ACCESSION NBR: 7904100285    DOC. DATE: 79/04/03    NOTARIZED: NO    DOCKET #  
 FACIL: 50-410 NINE MILE POINT NUCLEAR STATION, UNIT 2, NIAGARA MOHA    05000410  
 AUTH. NAME    AUTHOR AFFILIATION  
 RHODE, G.K.    NIAGARA MOHAWK POWER CORP.  
 RECIP. NAME    RECIPIENT AFFILIATION  
 DENTON, H.R.    OFFICE OF NUCLEAR REACTOR REGULATION

SUBJECT: INFORMS NRC THAT EXCEPTION TO SECTIONS 12.5.2.8.3 & 12.6 OF PSAR WILL BE USED IN CONST. NIAGARA MOHAWK INTENDS TO PERMIT UP TO ONE HALF INCH MISALIGNMENT FOR ERECTION OF BIOLOGICAL SHIELD WALL. *Trans bio shield wall diagram*

Re: Nine Mile Point Unit 2  
Docket No. 50-410

FIGURE 1

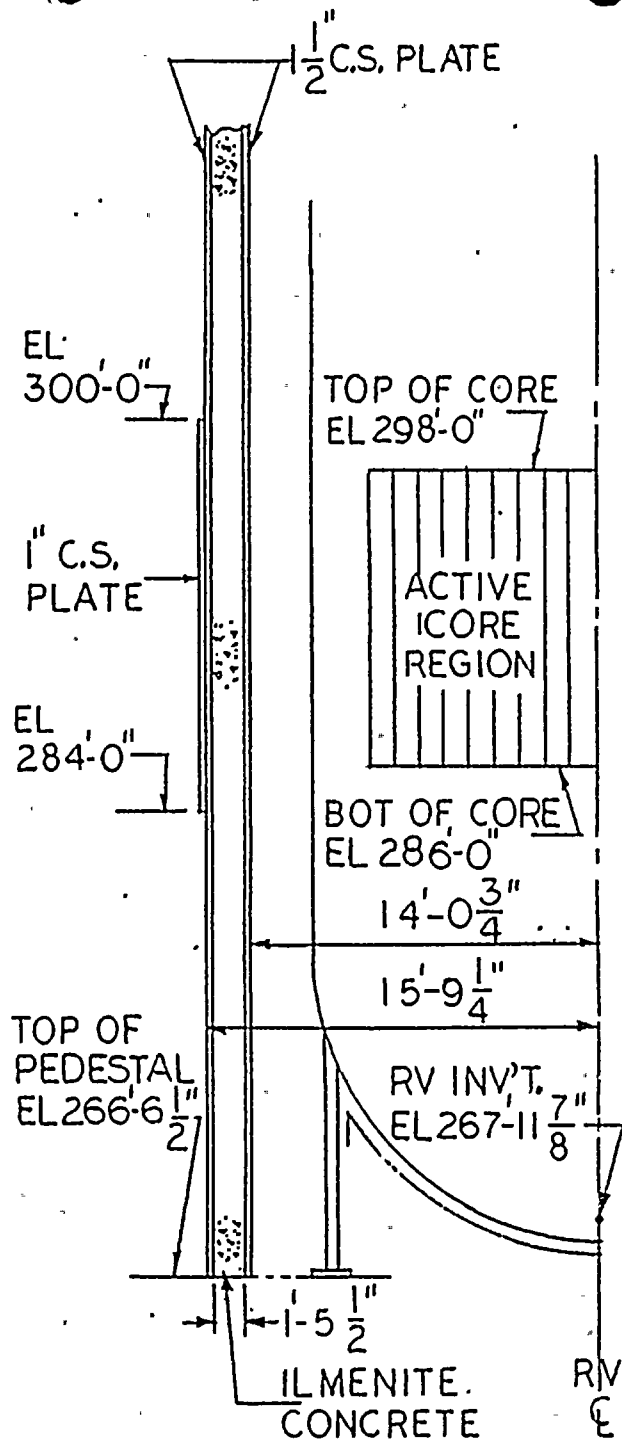
The biological shield wall is fabricated with two 1 1/2 inch steel plates connected by steel framing members. A cross-section of the biological shield wall is shown in Figure 1, attached. The biological shield wall is divided into three cylindrical rings with each ring subdivided into three, 120° sections.

The biological shield wall sections distorted radially outward when they were cut from the fabricating jig during shop fabrication. The field assembly contractor has used hydraulic jacking apparatus to attempt to fit up and align the biological shield wall sections to meet the allowable AISC specification misalignment tolerances. Since the biological shield wall may not be able to be brought into alignment in localized areas because of the limits of the jacking apparatus and the inherent stiffness of the structure, an alternative joint design has been developed and investigated for design adequacy.

This alternate joint design will allow misalignments greater than 1/8 inch but less than 1/2 inch in isolated cases, when it appears that jacking may be difficult to accomplish or undetermined stresses could be induced by jacking. A structural analysis of the entire biological shield wall rings with 1/2 inch misalignment shows that the stress level in the alternate joint design is within allowable limits of AISC-69.
